Application Number - MP08_0098 MOD 18
Main Project - MP08_0098
Assessment Type - SSD Modifications
Development Type - Gambling Activities
Local Government Area - City of Sydney
Location - 20-80 Pyrmont Street, Pyrmont
Applicant - Foundation Theatres
Consent Authority – Minister for Planning

31 May 2022

Star City Casino Upgrade Modification 18

Figure 3: The proposed Project site in relation to noise-sensitive receivers, and locations for both unattended long-term noise monitoring and attended short-term noise measurements

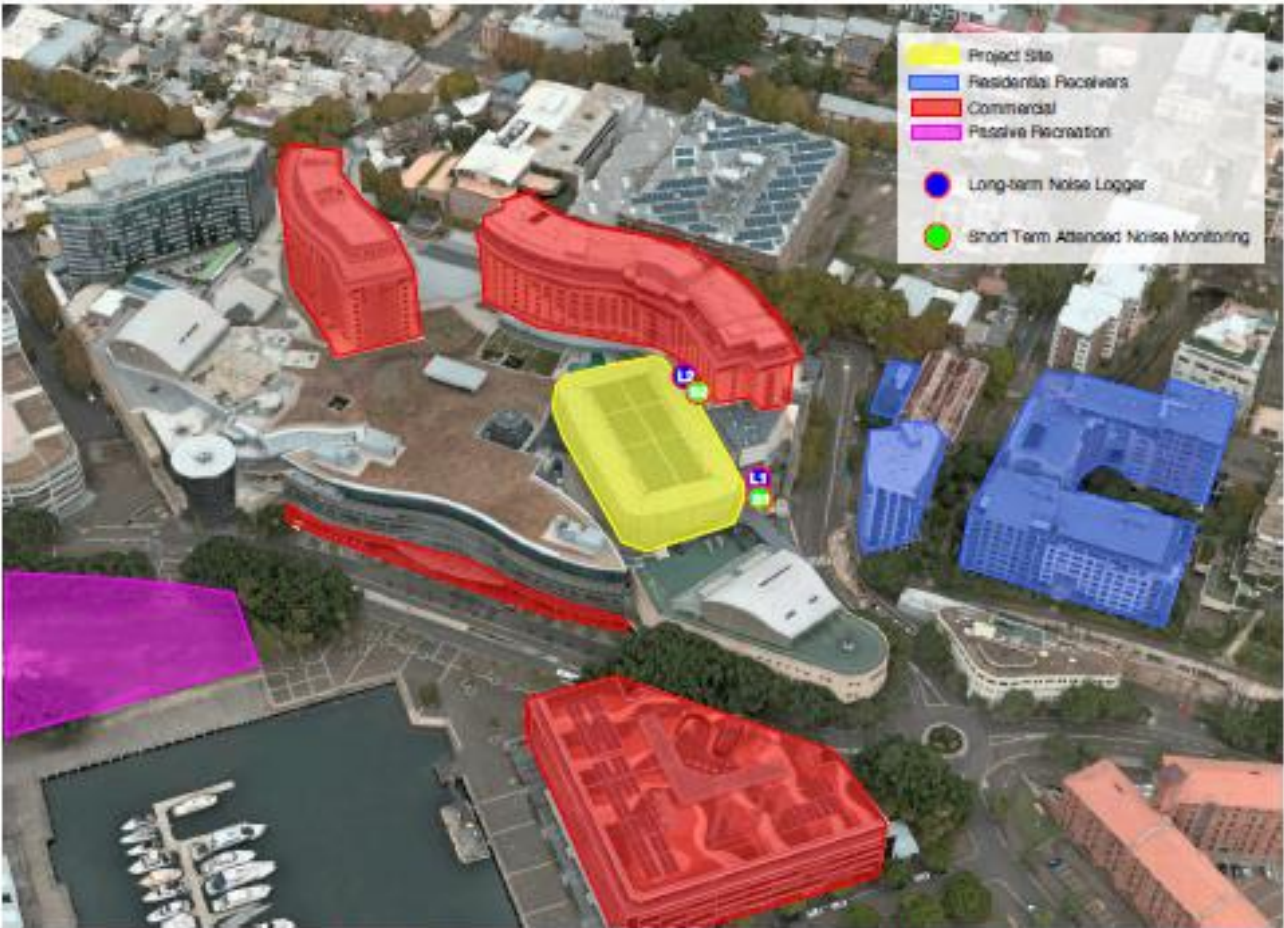
As residential property's running parallel to Jones Bay Road are three privately owned, purpose built, occupied residential terraces (marked in blue) as nearest noise/vibration-sensitive receivers (Figure 3) to the project site. And are of **equal importance** to the larger watermark building (in blue) behind the Jones Bay Road Watermark residence (in blue). See Image 1.

Missing from the existing noise environment summary of the nearest sensitive receivers surrounding the development site in Table 1. are the three privately owned and occupied residential terraces, approximately 30 meters distance from the MOD 18 site.

We understand the Watermark Tower residential building owner's corporation or strata manager did not provide permission to install a noise logger by Foundation Theatres and Acoustic Studio.

And considering the previous missing information in Item 2.4. Table 1. The other highlighted blue, three privately owned/occupied known sensitive receiver residential terrace owners/occupants were **not approached** by either Foundation Theatres or Acoustic Studio to arrange existing noise environmental, noise monitoring locations. See Image 2.

Consequently, this acoustic, vibration, construction noise receivers' assessment **results are misleading.**
